Site Plan
1632 River Road
Puyallup, WA 98371

PROJECT NAME:
LEGEND AUTO ADDITION

PROJECT ADDRESS:
1632 RIVER ROAD
PUYALLUP WA 98371

A1.0

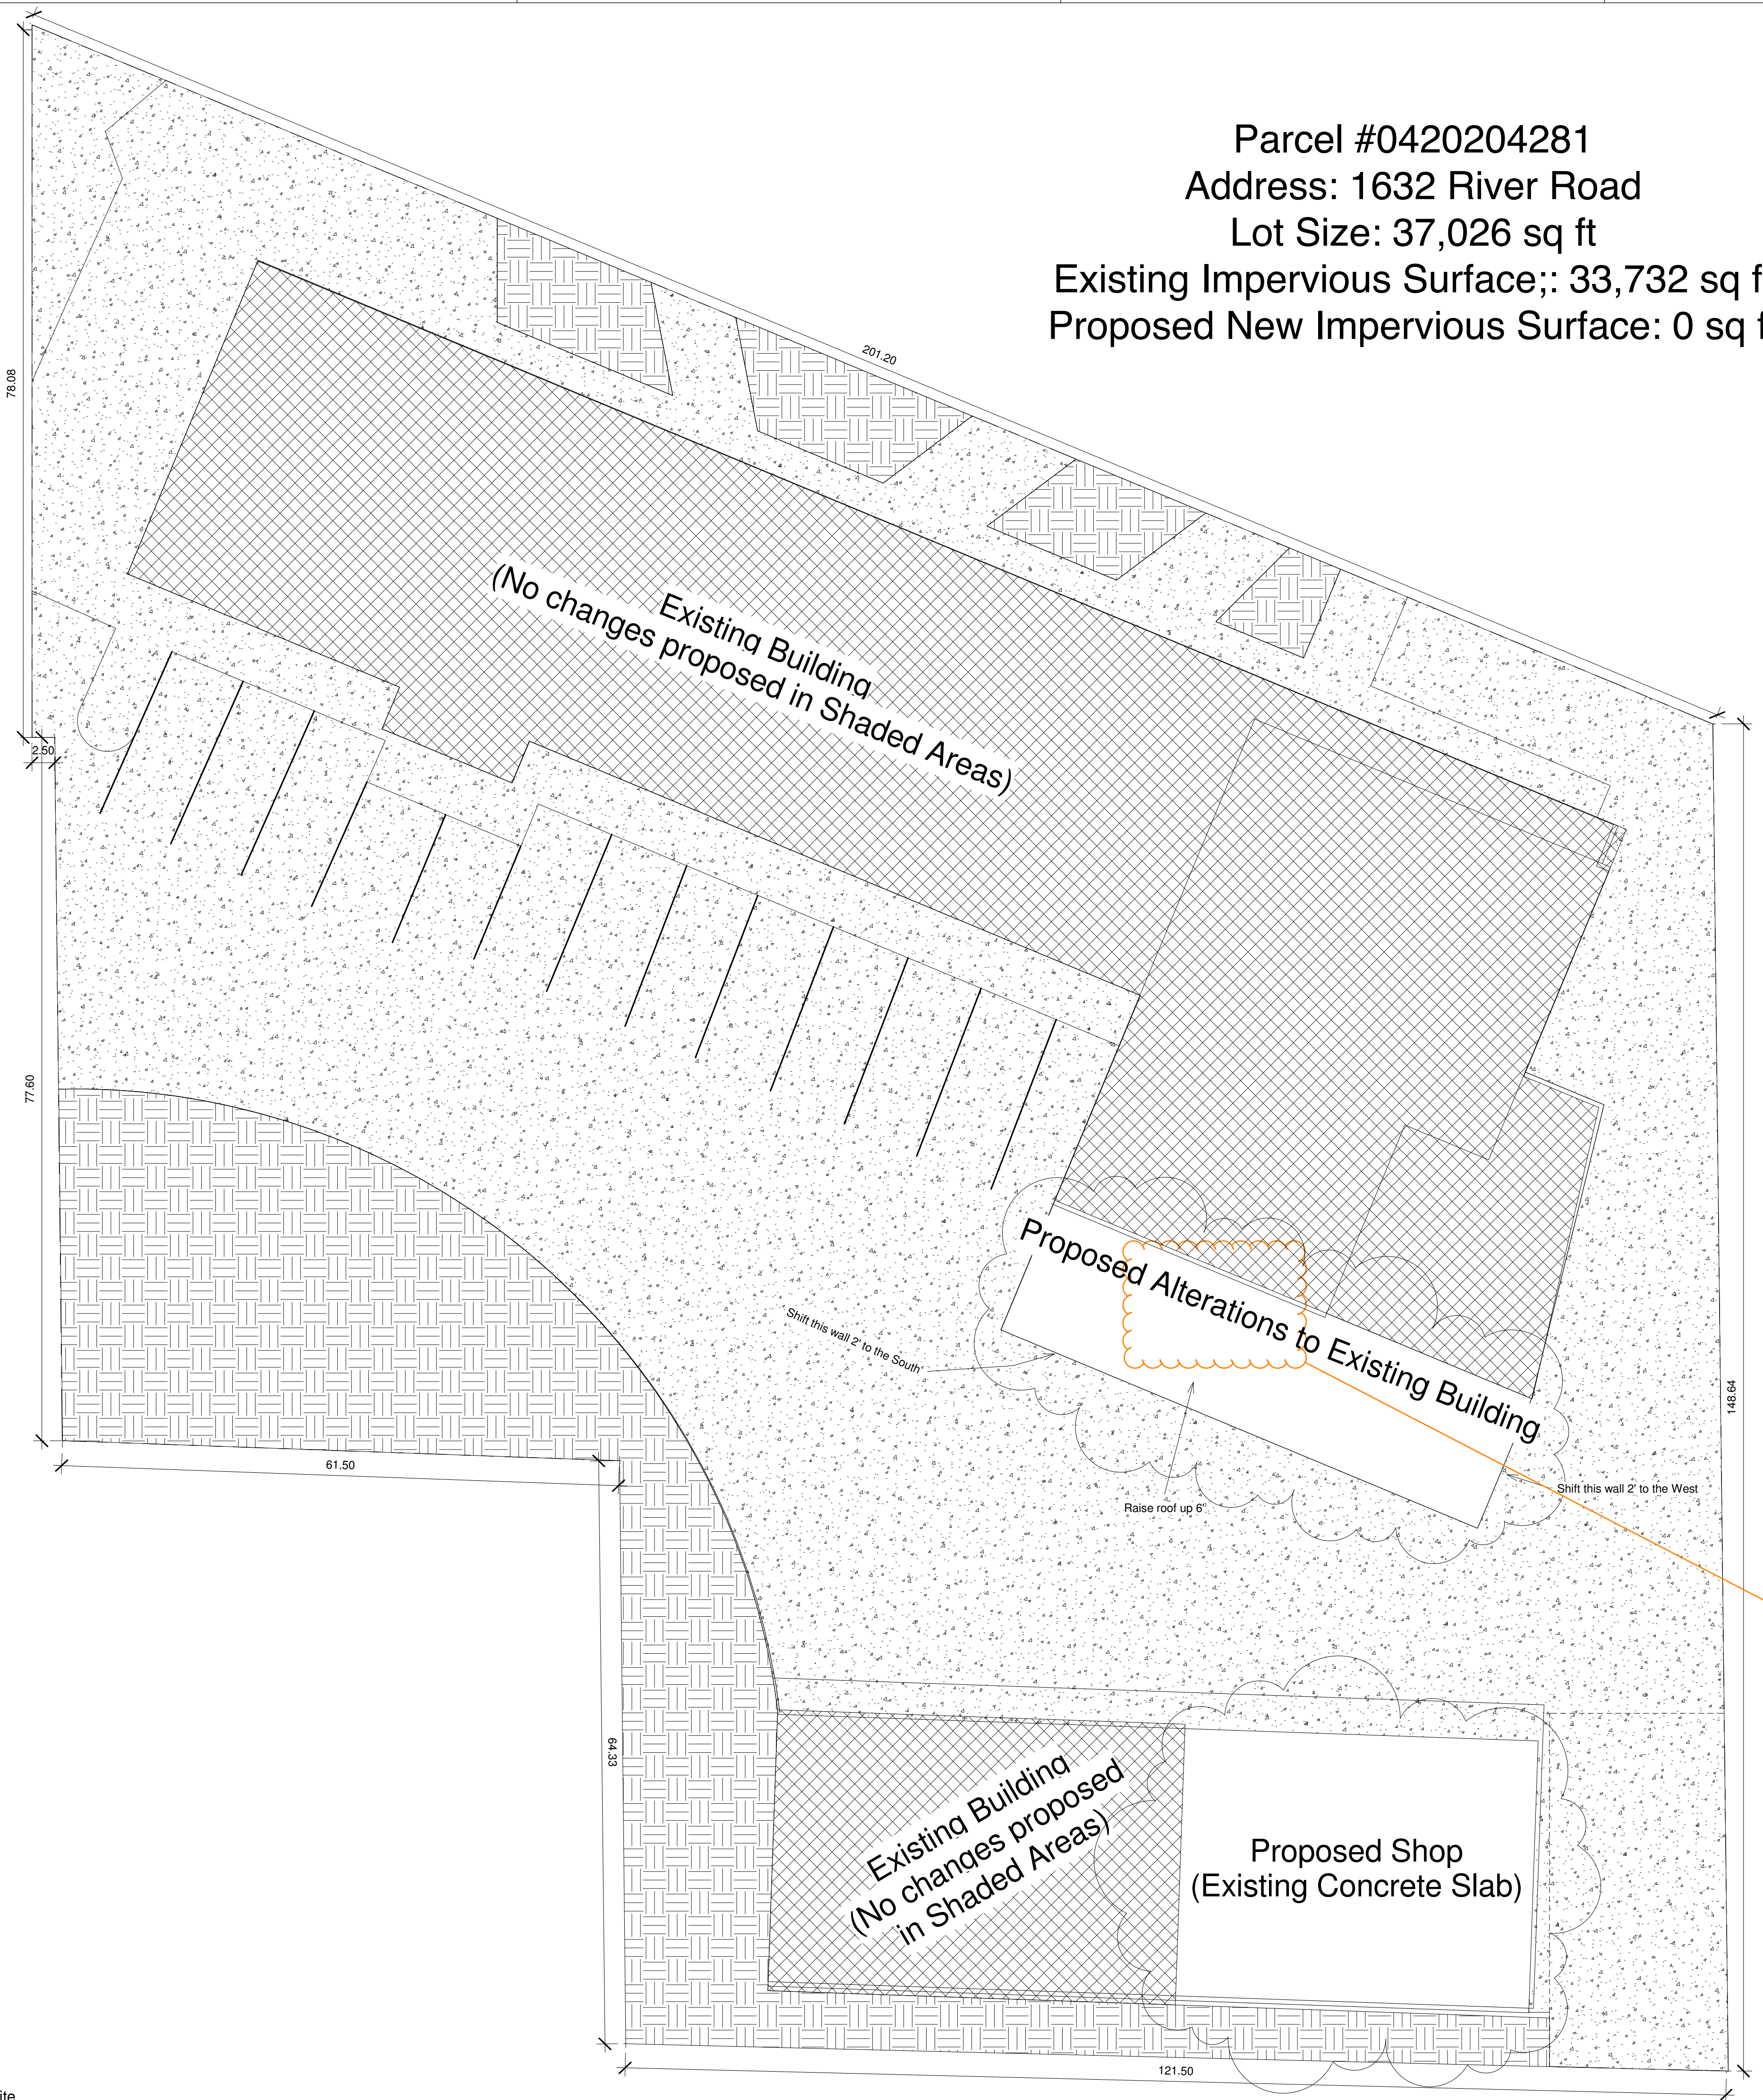
Please revise the plans and all notes to conform to the 2018 IBC and WSEC [1570 PLANS, sheet A1.0].

The notes on this sheet are for residential structures, and most are sections from the International Residential Code. Please remove all residential notes and include relevant commercial notes that apply to this specific project [1570 PLANS, sheet A1.0].

Please include the following Code Summary information:
Proposed Use, Construction Type, Occupancy Group Classification, Allowable Area, and Actual Area. [1570 PLANS, sheet A1.0].

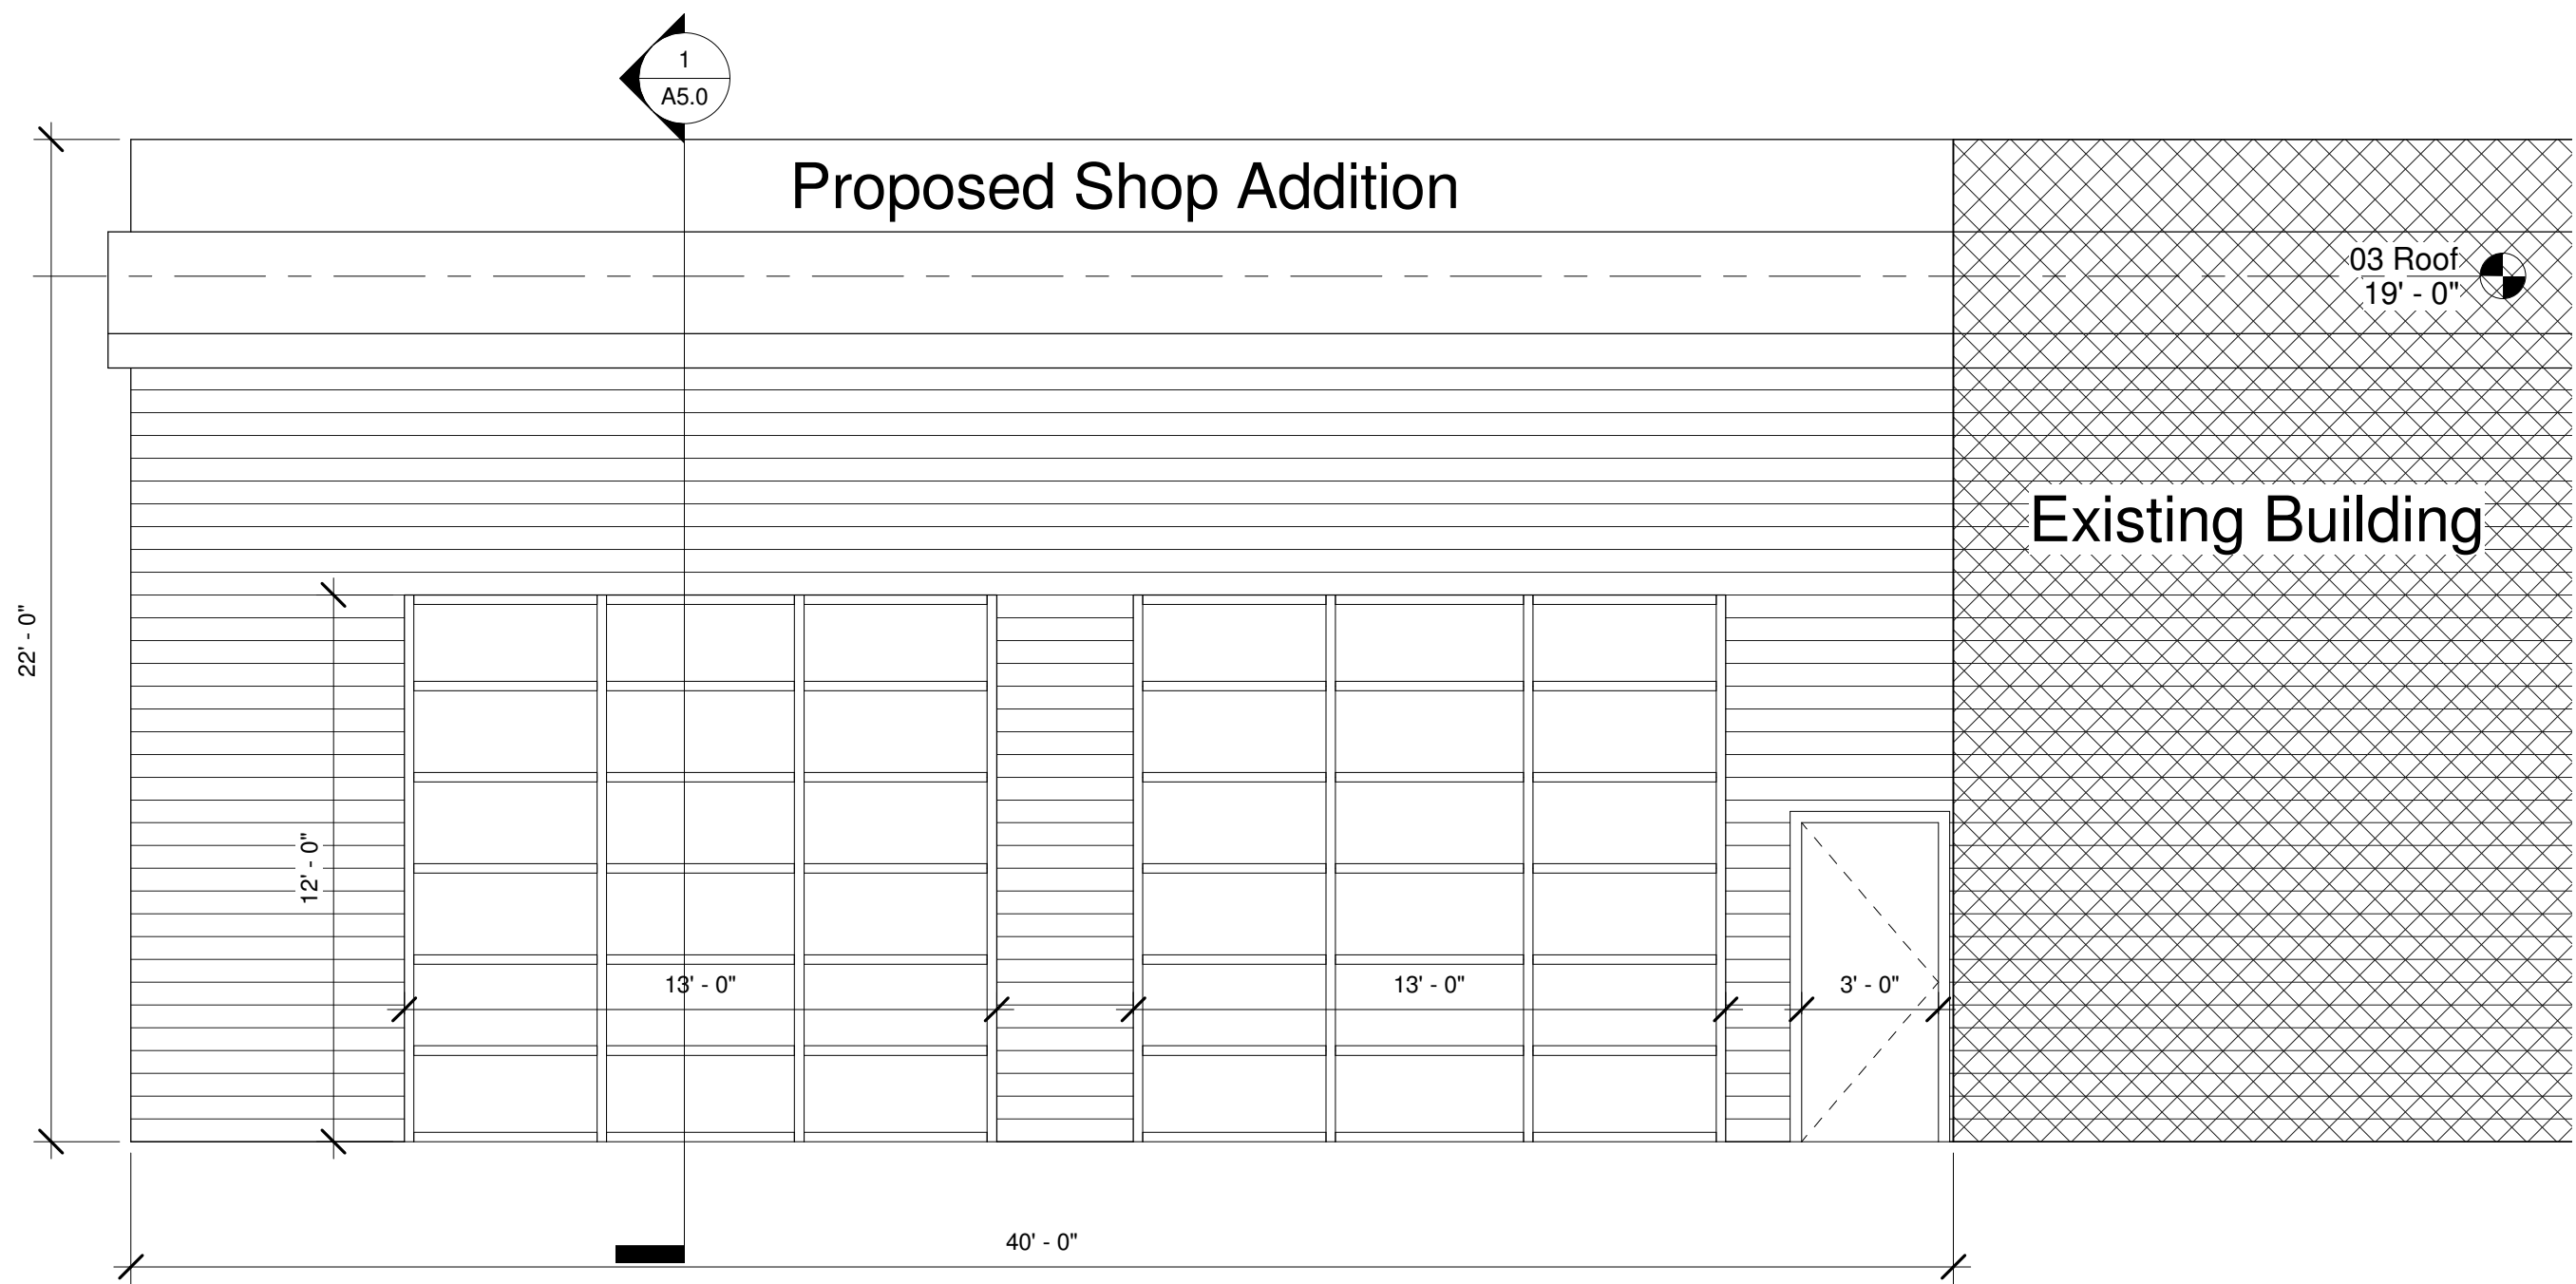
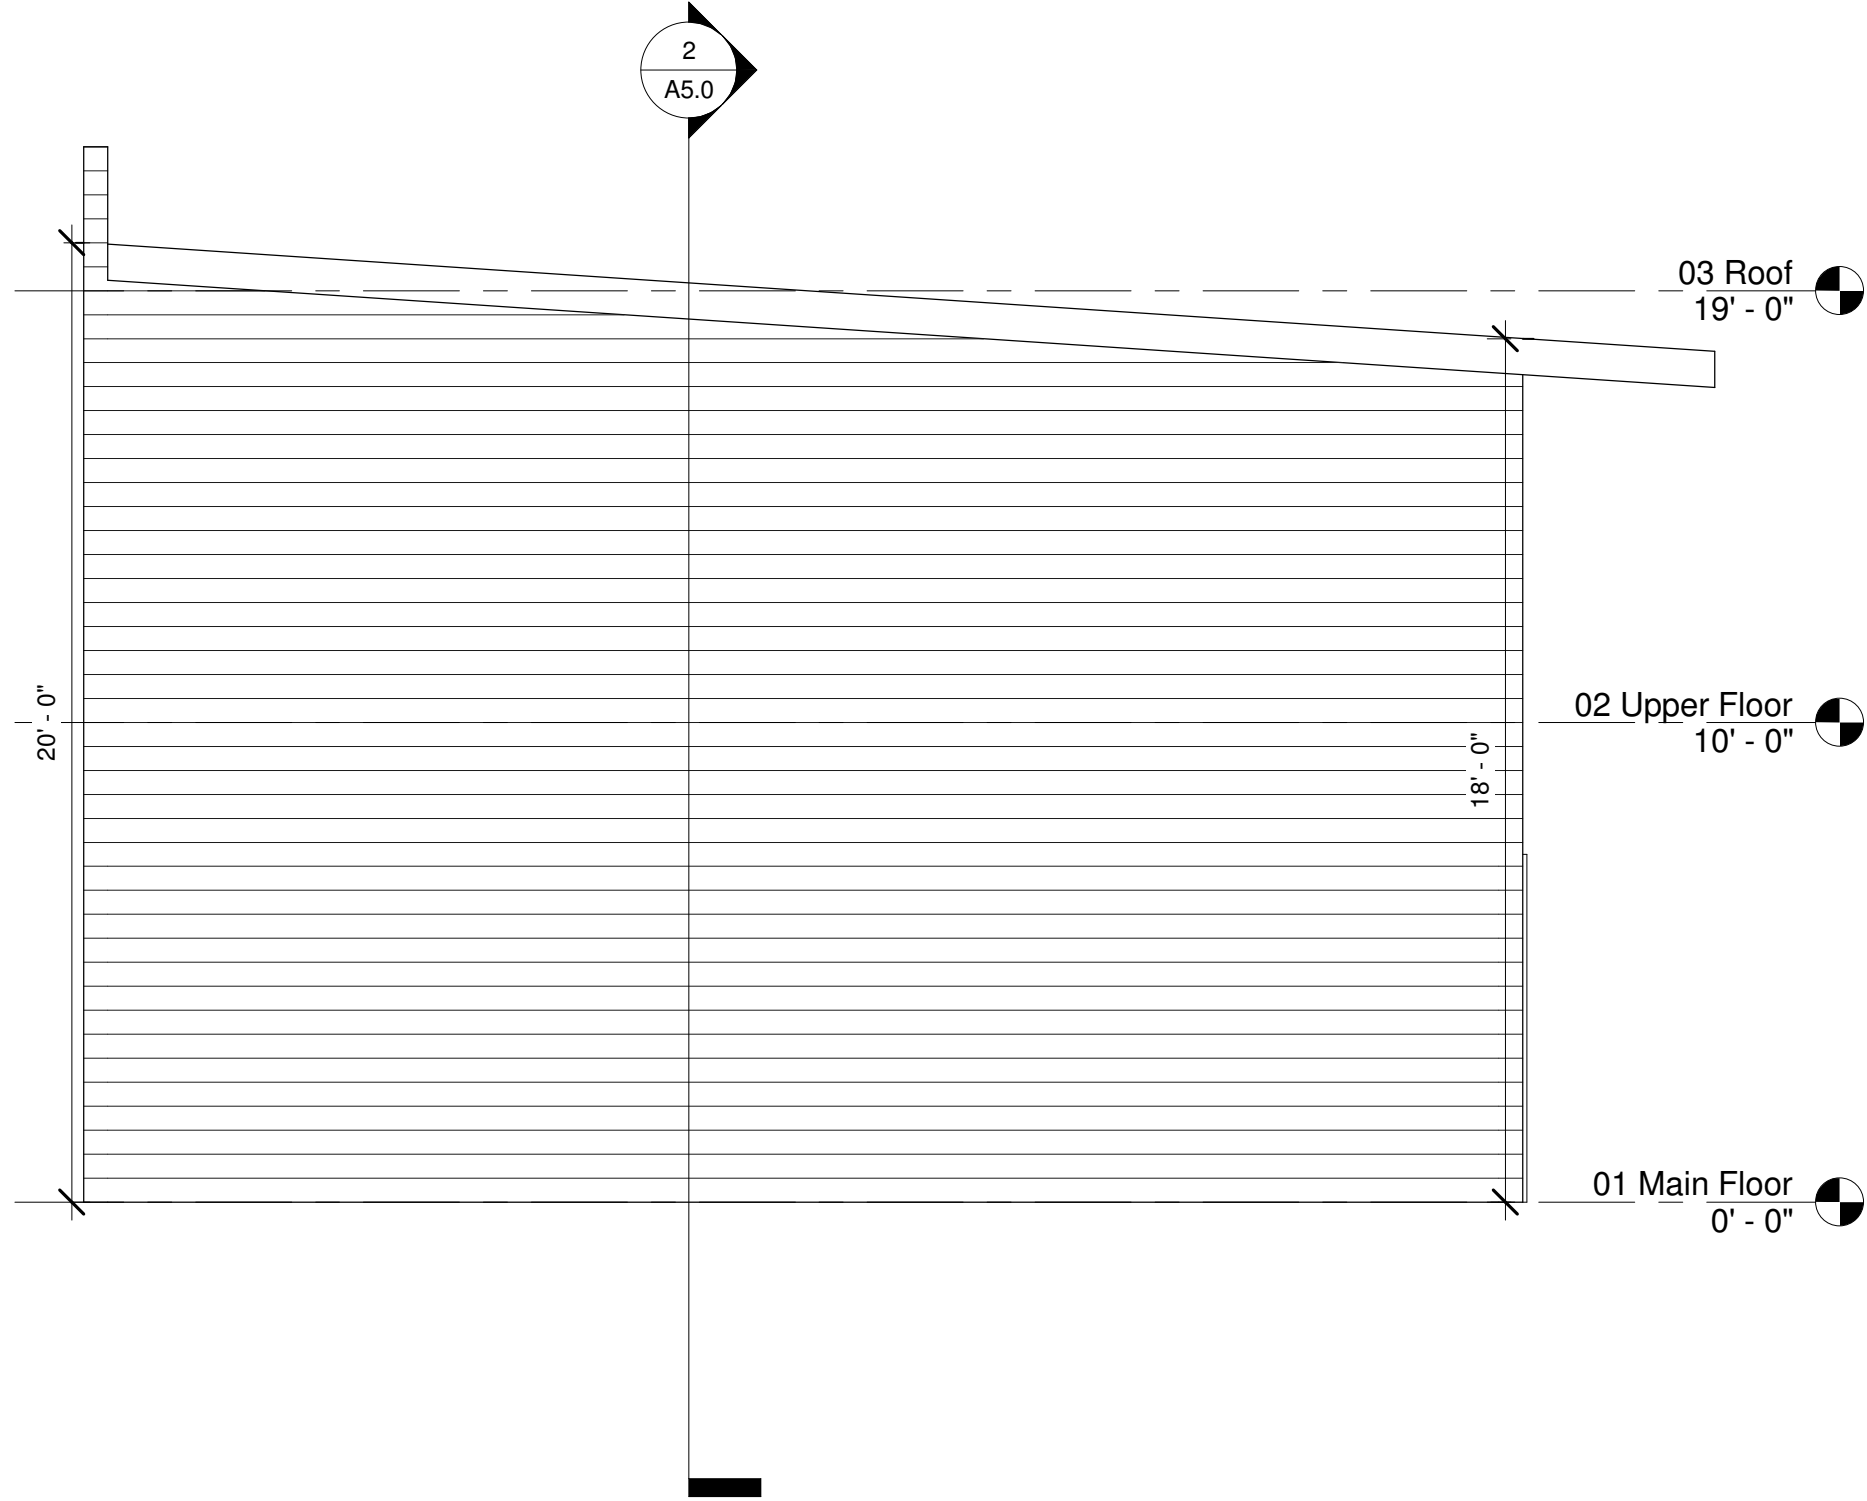
Attached in CityView you will find a document titled All Methods of Downspout Control. Methods described in this document must be implemented for the control of roof downspouts. Provide the City detailed information on methods that will be used. [1570 PLANS* Site Plan Sheet A2.0]

DETAIL. Methods described in this document must be implemented for sediment and erosion control during construction. Provide the City detailed information on the methods that will be used. [1570 PLANS* Site Plan Sheet A2.0]

Please provide the following dimensions on the site plan:
Length and Width of each proposed structure
Distance from each proposed structure to the property lines
[1570 PLANS, sheet A2.0].

The scope of work at this area would categorize this as an addition as everything, including the foundation, is new
[1570 PLANS, sheet A2.0].
